**REPLY TO REQUEST FOR ADDITIONAL INFORMATION
INET SPIDER II MODEM
FCC ID MIVWG9701A**

SECOND INFORMATION REQUEST

This document has been compiled to reply to a series of questions posed by the FCC as part of the Equipment Authorization Process for the Inet Spider II Modem (FCC ID MIVWG9701A). Each of the questions listed by the FCC is listed prior to the reply.

FIGURE 1 MODULATION VERSUS INPUT SIGNAL RESPONSE

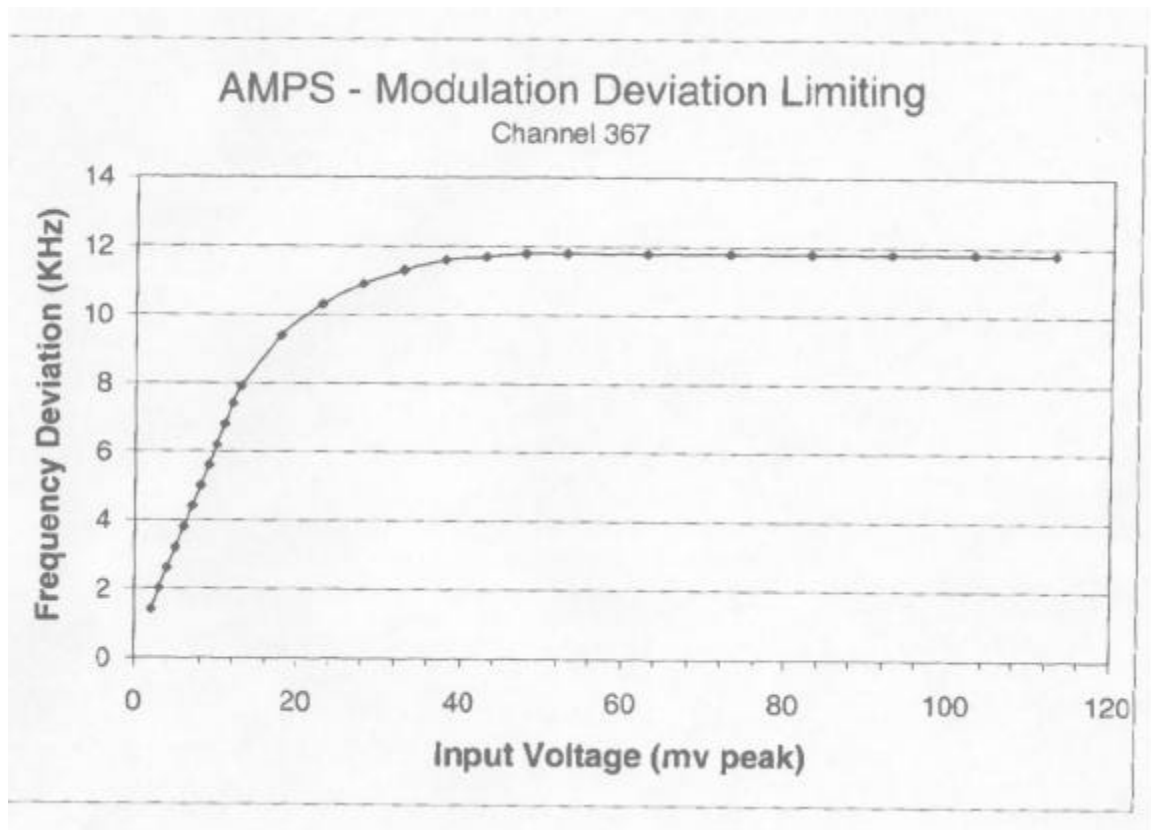
1) Please provide a plot of the deviation versus input signal level.

This plot is shown below:

FIGURE 2 TRANSMIT AUDIO SIGNAL PATH

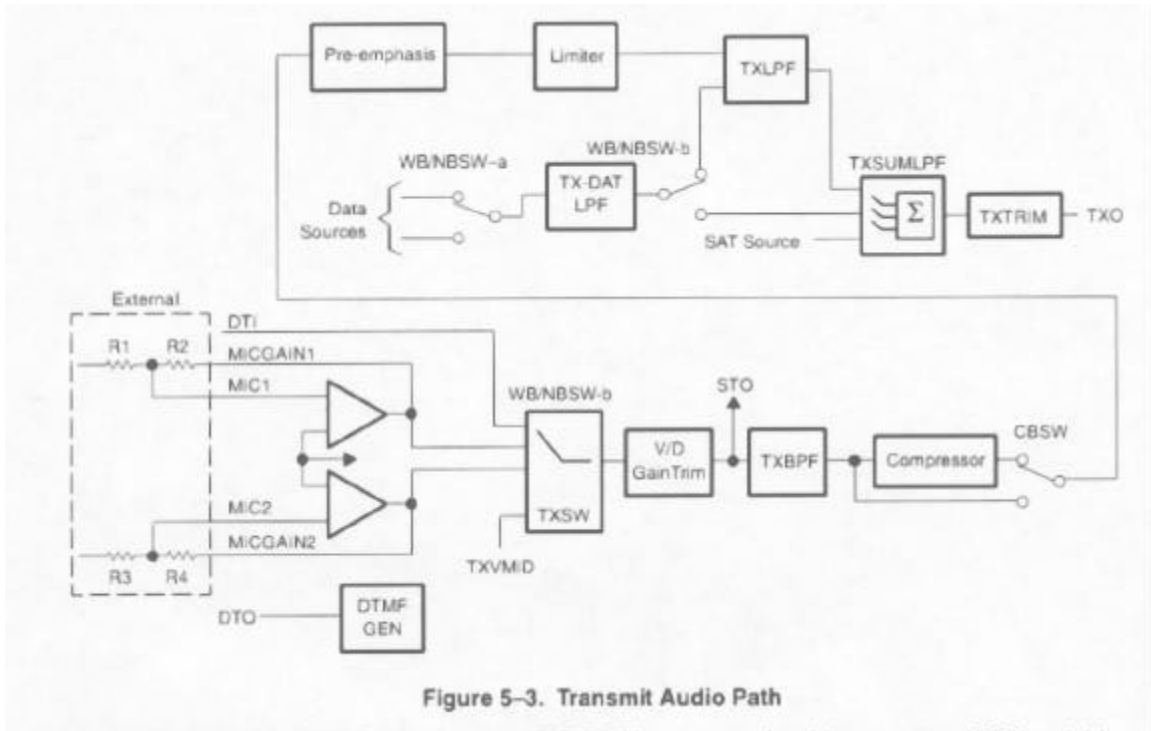
2) The audio filter response requested earlier (showing compliance with 22.915(d)(1)) is for the post limiter filter. The test description from the previous reply indicates that the generator was connected to the audio port.

The Spider II uses an integrated DSP chipset for the signal processing & generation functions. The post-limiter filter is embedded into a Texas Instruments TCM8030 Baseband Signal Processor chip between the modulation limiter and the modulator. A block diagram of the transmit audio path portion of this circuit is shown in Figure 2. The post limiter audio filter is shown as TXLPF. The frequency response of this component (as obtained from Texas Instruments) is shown in Figure 3. The curves shown in Figure 3 are compliant with the specifications of §22.915(d)(1).
